Addendum 1

File # 18-0116E (18-10AA)

Project: Dead Ship Two – Temporary Relocation of the William A. Irvin

Re: William A. Irvin Dead Ship Tow Bid No. 18-0116E: Addendum #1

S1.0

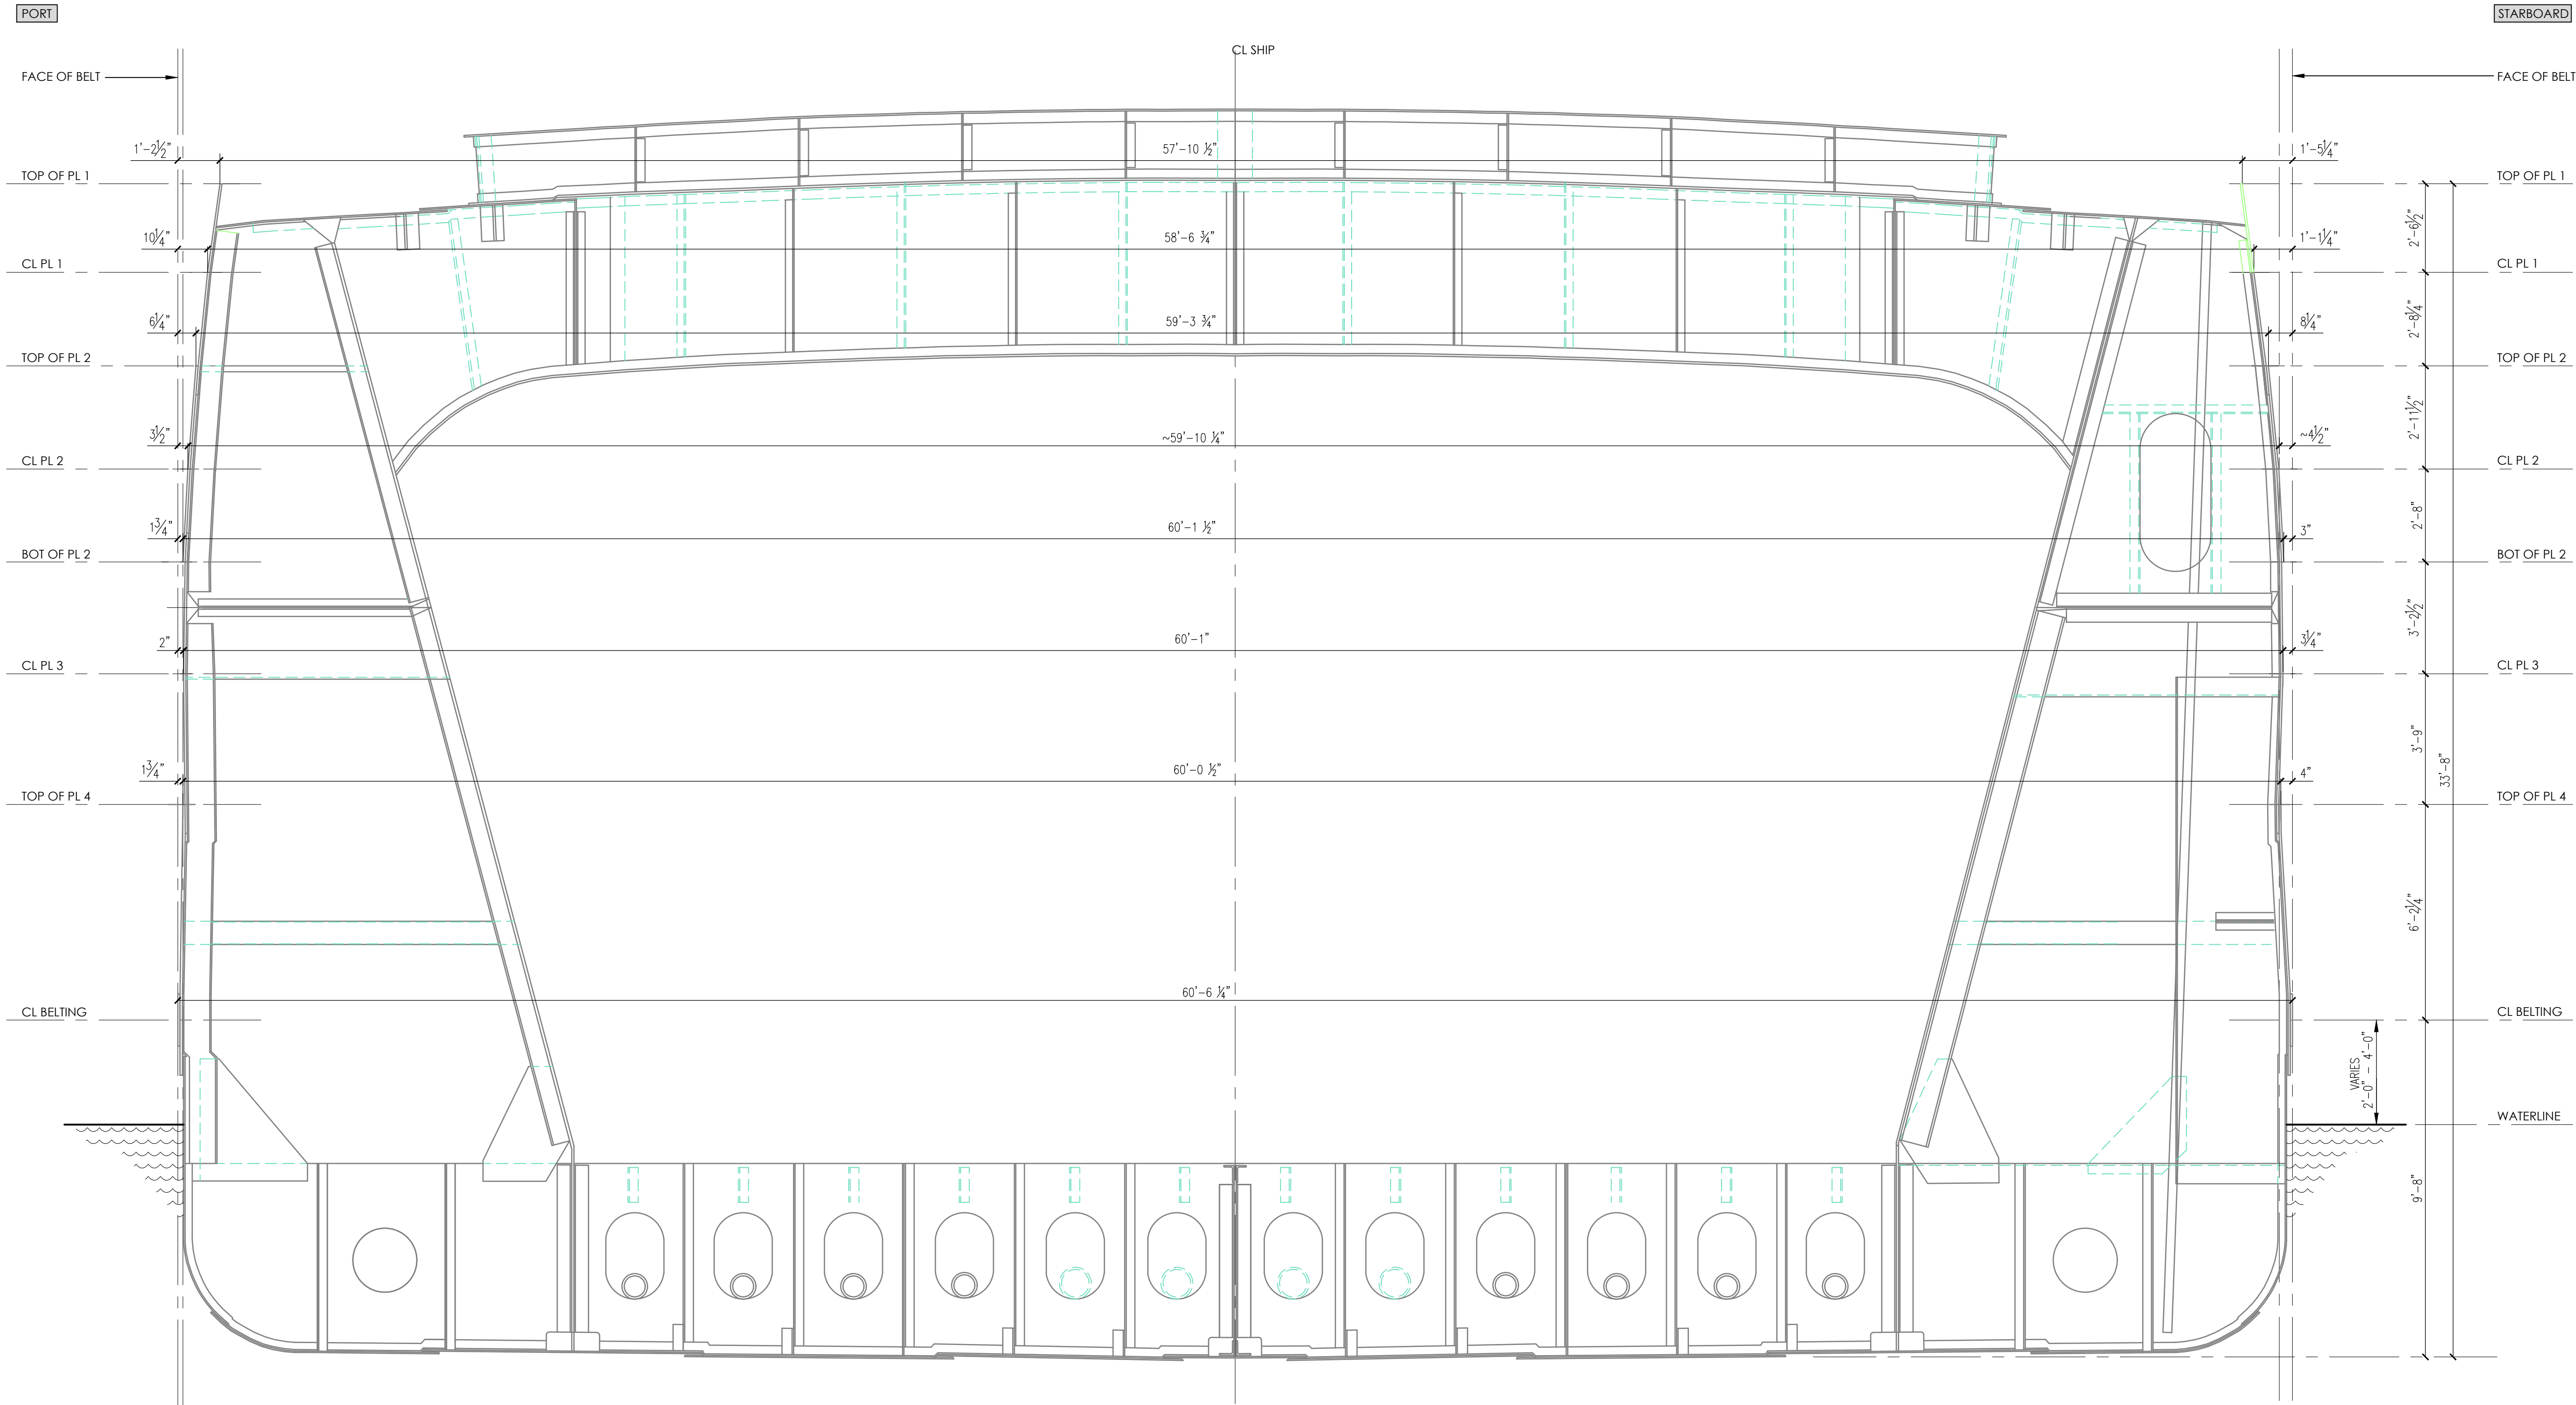
- The allowable deflection of the temporary guide wall will increase as the vessel moves further from the MN Slip Pedestrian Bridge. The maximum allowable deflection at the outer corner of the dock wall will be 6". The maximum allowable deflection will linearly increase to 2'-0" at 200 lineal feet from the corner of the dock wall.

- The new dock wall, which is currently being constructed, will include eight new 65-ton staghorn bollards spaced at approximately 100-foot intervals. The plans have been updated to include the approximate location of the bollards.

REV. BY:	CAD
DESCRIPTION	Vertical Pile Options & Spacing
REV:	1
DATE:	7/16/18

1
S6.0 MINNESOTA SLIP REDESTRIAN BRIDGE
SCALE: 3/16" = 1'-0" ON 22" x 34" PLOT

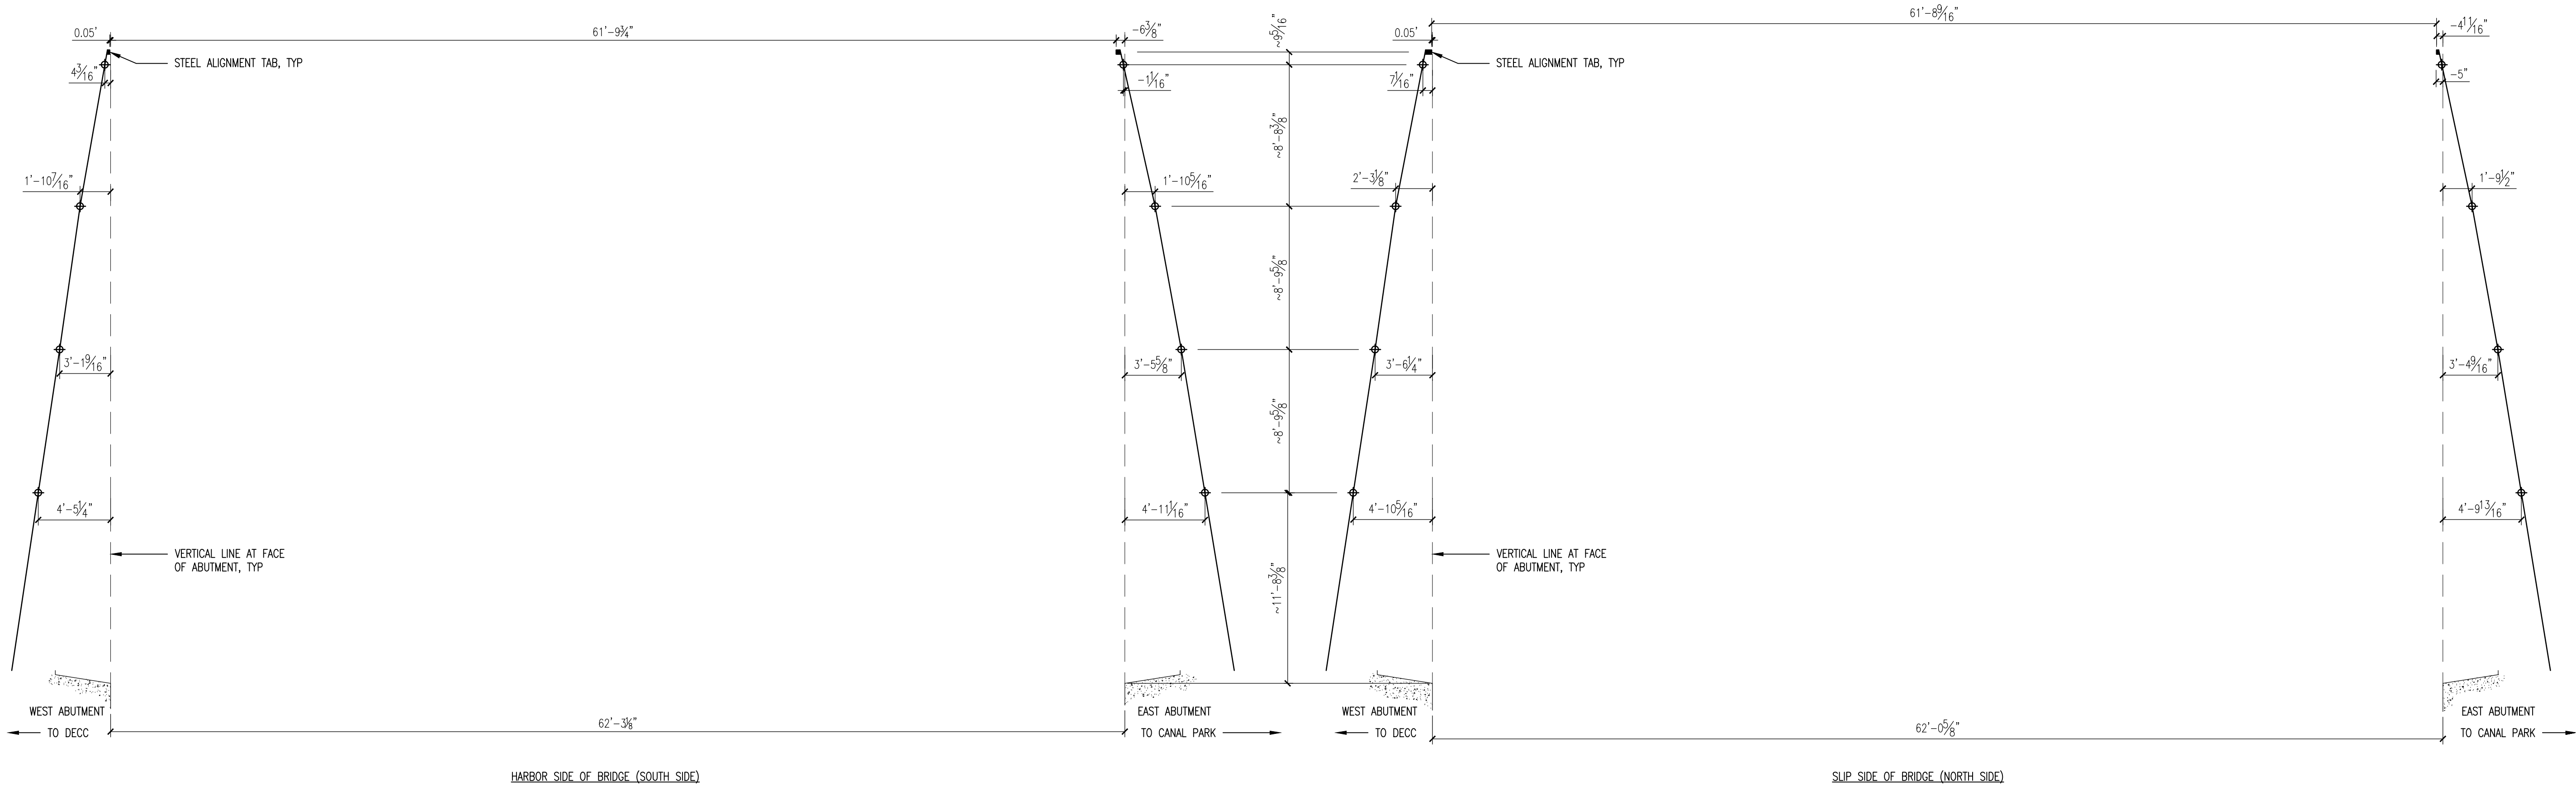
- Additional water ballast can not be added to the vessel since the sea chests have been completely welded shut.
- Since the steel bridge members of the MN Slip Pedestrian Bridge overhang the face of the concrete abutment on the canal park side (east side), the City of Duluth will issue a separate contract to pull the steel members past the face of the concrete abutment. The steel bridge members on the DECC side (west side) will not be altered. It is the responsibility of the Contractor to coordinate with the DECC, City of Duluth & the Contractor performing the required bridge work. The bridge Contractor will also be required to provide a redundant system to hold the bridge members in position during the relocation process.

THE CITY OF DULUTH WILL PARTIALLY DISASSEMBLE THE BRIDGE ON THE CANAL PARK (EAST) SIDE SO THAT ALL COMPONENTS ARE BEHIND OR INLINE WITH THE FACE OF THE CONCRETE ABUTMENT. CONTRACTOR IS RESPONSIBLE FOR VERIFYING THIS CONDITION PRIOR TO IRVIN MOVE.
